◆ Technical Bulletin Technical Bulletin ◆

Model: DBM-70
Subject: DFC Collator Connection

DFC Collator Set-up

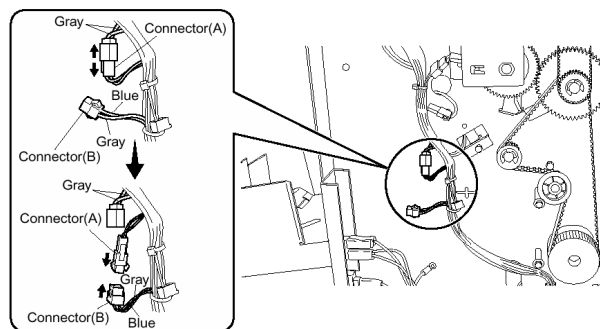
Please refer to section 4 of the DFC Installation Manual; 'Re-Connect the Connectors'. Locate the respective connector within the Non Operator side panel and change the connections to Grey Blue to Grey Blue.
